CODE ANALYSIS

A Remodel for
STEAMBOAT CHRISTIAN CENTER
821 DOUGHERTY ROAD
TR IN SE4SW4 SEC 28-6-84, TOTAL 5 ACRES
STEAMBOAT SPRINGS
ROUTT COUNTY, CO

ISSUE DATE: 07/29/2025 PERMIT
PROJECT NO: 25011
SHEET TITLE: GENERAL NOTES, FLOOR PLAN(S), SCHEDULE(S)
SHEET NO: A2.0

2 NEW MAIN LEVEL PLAN

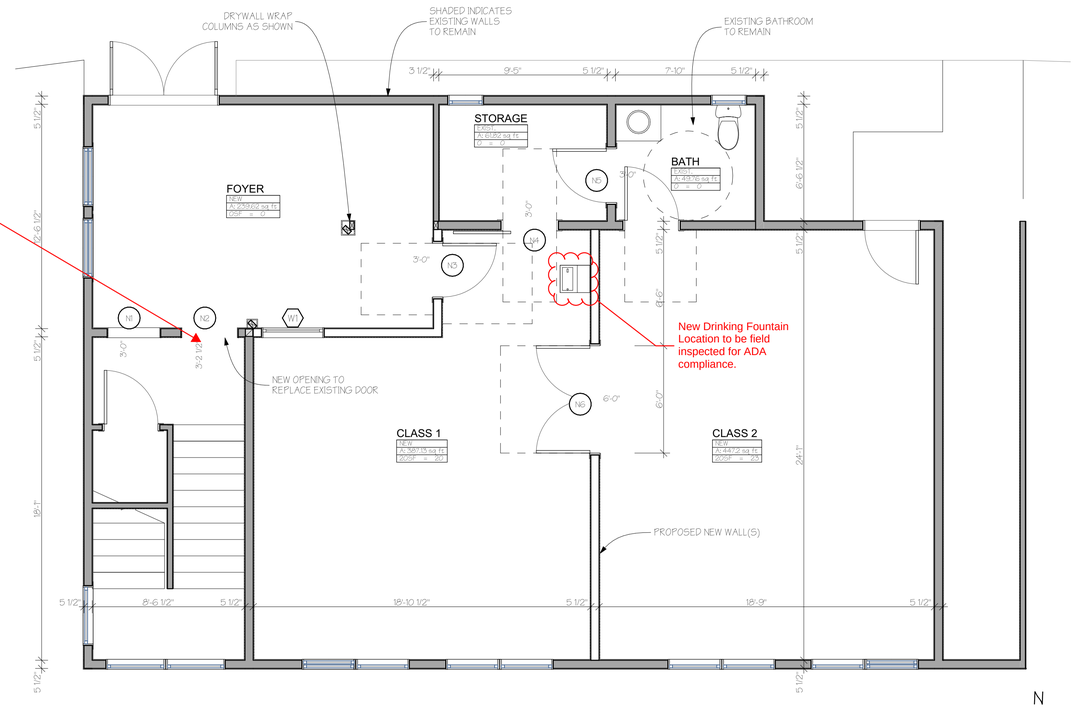
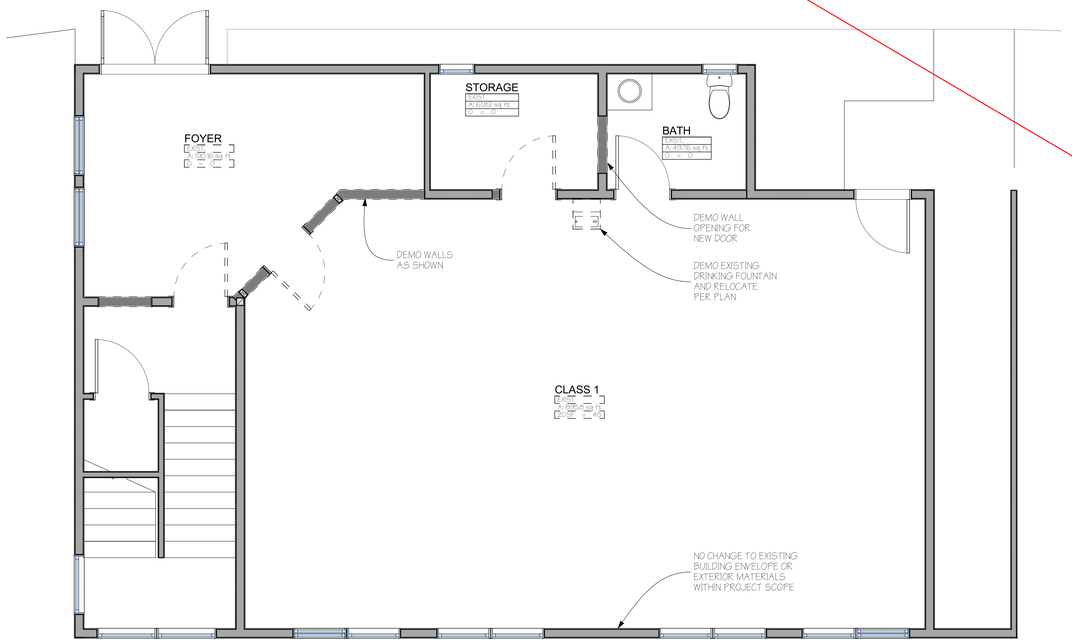
RCRBD Comments:
This Building is also an Educational
E-Occupancy Use and the Architect of Record is using the Occupant Load Divider Factor in chapter 10 from table 1004.5 of 20 net to add up occupant loads.

RCRBD Condition Added to permit approve requesting verification to be provided by the Architect on the existing stairs that lead to the second floor. Our concern is no fire ratings were mentioned on any existing walls or doors, and it is possible none exist, but our concern is to have information back stating the stairs were never rated or separated by any fire assemblies from the type of occupancy use on the 2nd floor and occupancy uses on the main floor, as a rated possible interior exit stair. We ask this information now, because your removing a door at the bottom that may have been installed if a rating was required for these exit stairs from the 2nd floor. Please provide us a response and supporting code information back per our condition added to our approval.
